JONESFIELD TOWNSHIP – SECTION 1

The comments below are based on conformance with the Jonesfield Township Zoning Ordinance and the approved Nov 18 resolution that incorporates DTE’s design parameters, for Turbines T-83 and T-84 in Section 1.

To: Jonesfield Township Planning Commission
From: Alan Bean, AICP – Spicer Group, Project Planner (alanb@spicergroup.com)
Jennifer Stewart, AICP – Spicer Group, Community Planner (jennifer.stewart@spicergroup.com)
RE: Review of DTE's Meridian Wind Park Special Land Use Permit Application – Site Plan Review

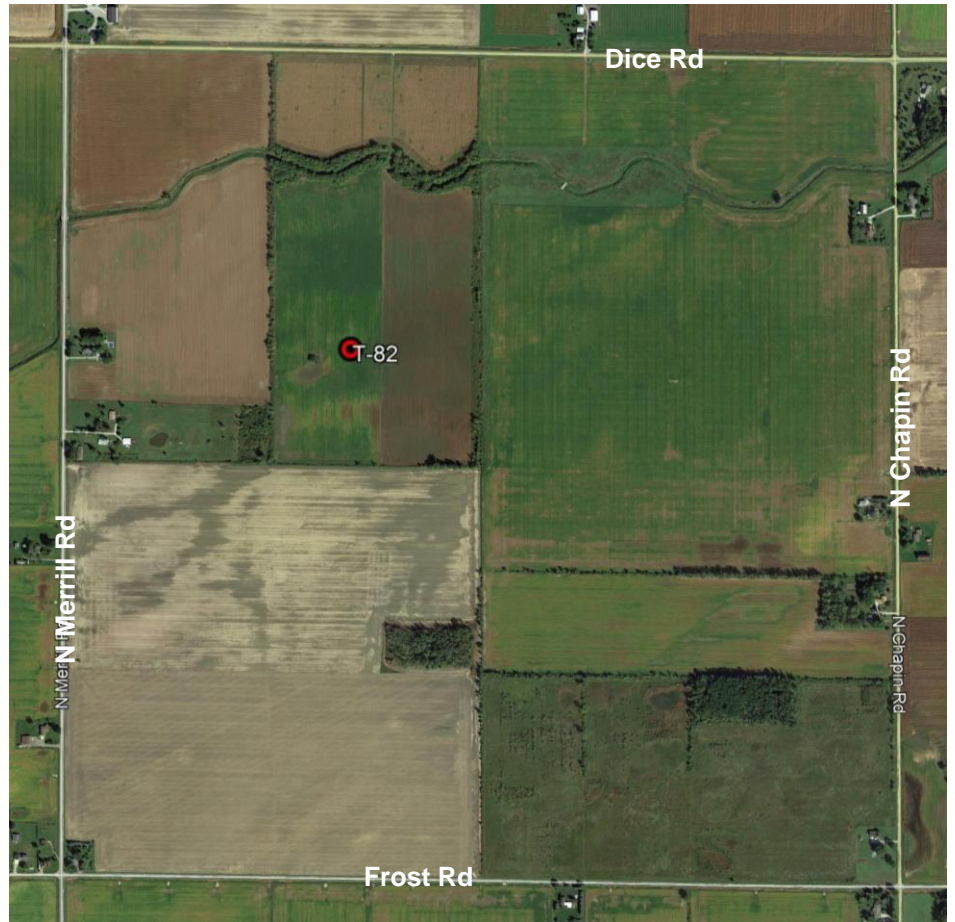
Shadow Flicker – In Appendix A of the shadow flicker report, Receptor 1050 is modeled to have 28.6 hours of shadow flicker. However, the contour map of Section 13, it appears the red 30-hour contour line crosses directly over the home. The applicant needs to clarify this discrepancy. If the receptor exceeds the 30-hour limit, the applicant shall implement shadow flicker mitigation measures for this home.

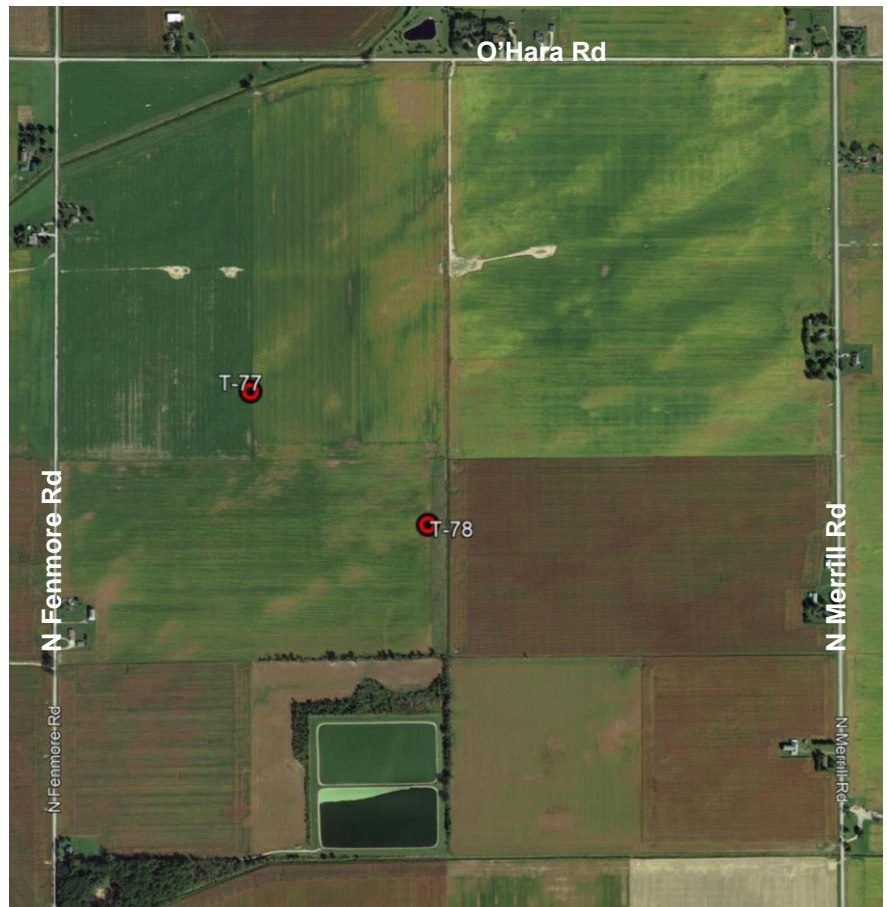
Shadow Flicker – In Appendix A of the shadow flicker report, Receptor 1210 is modeled to have 27.5 hours of shadow flicker. However, the contour map of Section 4, it appears the red 30-hour contour line crosses directly over the home. The applicant needs to clarify this discrepancy. If the receptor exceeds the 30-hour limit, the applicant shall implement shadow flicker mitigation measures for this home.
